U24/0621 – TWO X TWO STOREY DWELLINGS AT LOT 4 (NO. 8) BIRDWOOD ROAD, MELVILLE WA 6156 (REC) (ATTACHMENT)

Ward : Palmyra - Melville - Willagee Ward
 Category : Operational
 Application Number : DA-2023-720
 Property : Lot 4 (No. 8) Birdwood Road, Melville WA 6156
 Proposal : 2 x Two Storey Grouped Dwellings
 Applicant : S J Delmenico
 Owner : Anita Lilian Delmenico, Kevin Wayne Delmenico and Kelly Maree Delmenico
 Disclosure of any Interest : No Officer involved in the preparation of this report has a declarable interest in this matter.
 Responsible Officer : Gavin Ponton
 Acting Manager Statutory Planning
 Previous Items : N/A

**U24/0621 – TWO X TWO STOREY DWELLINGS AT LOT 4 (NO. 8) BIRDWOOD ROAD,
MELVILLE WA 6156 (REC) (ATTACHMENT)****KEY ISSUES / SUMMARY**

Figure 2: East elevation for lot 880, as viewed from the east adjoining lot 10 Birdwood Road.

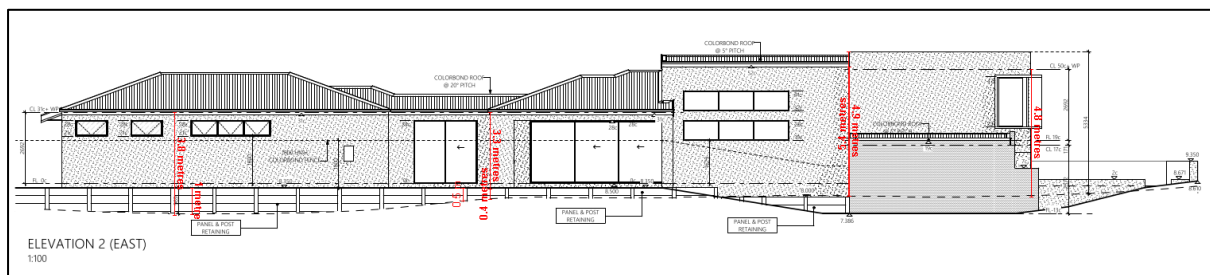
The proposed development is seeking a performance assessment for the site works to the east boundary as outlined above in the detail section of this report. The design principles of Clause 5.3.7 Site Works of the R-Codes seek to ensure that development responds to the existing natural features of the site, mitigates any amenity impact as viewed from the street and adjoining lots, and does not detrimentally affect adjoining properties. The proposed extent of site works along the eastern site boundary is considered to meet the design principles as discussed below.

- The dwellings are stepped down to reduce the visual impact from the street, and balance cut and fill, to reduce the impact upon the east side property whilst maintaining a functional outdoor area for use by occupants. The highest level difference between the two proposed units 8A and 8B, and the east side retaining wall varies with the slope of the land such that site works along the front half of the lot on the east side boundary is compliant with Clause 5.3.7 of the R-Codes and includes a portion of excavation. This is shown in the first image below (street boundary on right hand side), and the area which is more than 0.5m above NGL is for part of the boundary only, shown in the second image below.

- The site retains a slope down from the street boundary into the garage as shown in the first image below. This reduces the visual impact on the street. The ground floor level is otherwise set back from the east side boundary, limiting the impact of site works and dwelling to the openside and rear outdoor living area (OLA), reducing the visual impact on the east and south adjoining lots. As per figure 2 & 3, the area which is higher than 0.5m does not align with a major opening or a limited area of functional outdoor space. Instead, the fill and retaining aligns with an open space that is part of a larger backyard area sufficient for a wide array of external uses.

- The boundary adjacent to 10 Birdwood Road undulates as noted above and levelling the site for higher internal amenity is not considered to create an unnecessary bulk on the large rear OLA of 10 Birdwood Road. As the sites are oriented north to south, and the dwelling at 10 Birdwood Road is on the east side, there will be minimal impact on solar access for major openings, outdoor spaces, and solar collectors across this site. With regards to visual privacy for the rear OLA, this will be mitigated through the construction of a sufficient dividing fence.

Figure 4: cone of vision from Lot 880 (right) to No. 10 (left) with yellow highlight indicating required balcony screening.

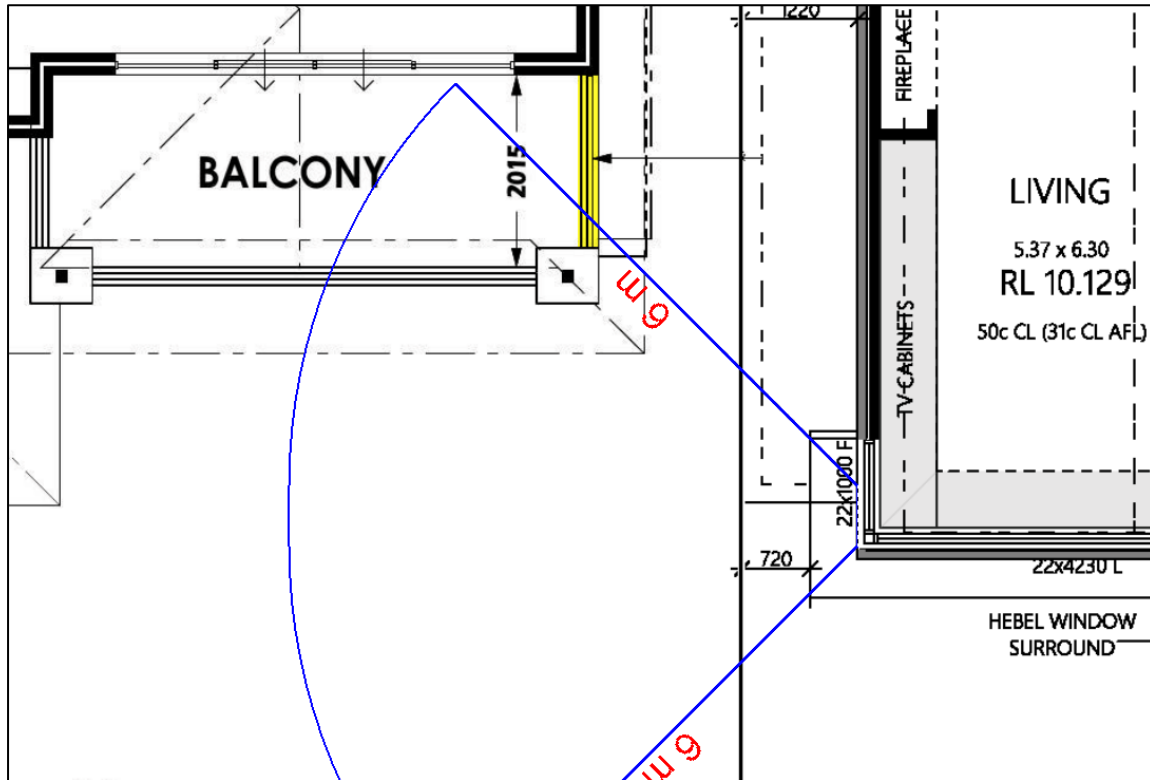
The proposed development is seeking a performance assessment for the overlooking from the upper floor living room of the eastern dwelling towards No. 10 Birdwood Road as outlined above in the detail section of this report. The design principles contained in Clause 5.4.1 Visual Privacy of the R-Codes seek to reduce direct overlooking into outdoor active habitable spaces and major openings of habitable rooms, and to include design features and screening which remove overlooking or maximise the setback of sources of overlooking from sensitive areas. The proposed overlooking from the living room is considered to meet the design principles as discussed below.

- Overlooking from the living room window is mitigated as shown in images four and five below due to the installation of cabinetry along the east side wall, ensuring that residents are not able to stand directly at this window, and by the installation of a short vertical fin extending from the window, limiting views towards the neighbouring dwelling.

- The proposed major opening and primary light source to the living room is street facing on the northern wall, with a narrow complementary window on the east side. Locating the east facing window at the northern corner of the room minimises the potential overlooking on the east side lot whilst providing additional natural light for the subject site dwelling.

- As shown in figure 4 and discussed above, the proposed dwelling (right hand side) reduces the potential overlooking with permanent screening from the vertical fin, limiting the east facing views to the area in front of the dwelling.

- It is further noted that the front balcony at 10 Birdwood Road is required to be screened under the terms of its development approval. The required screening would further mitigate the potential loss of visual privacy.
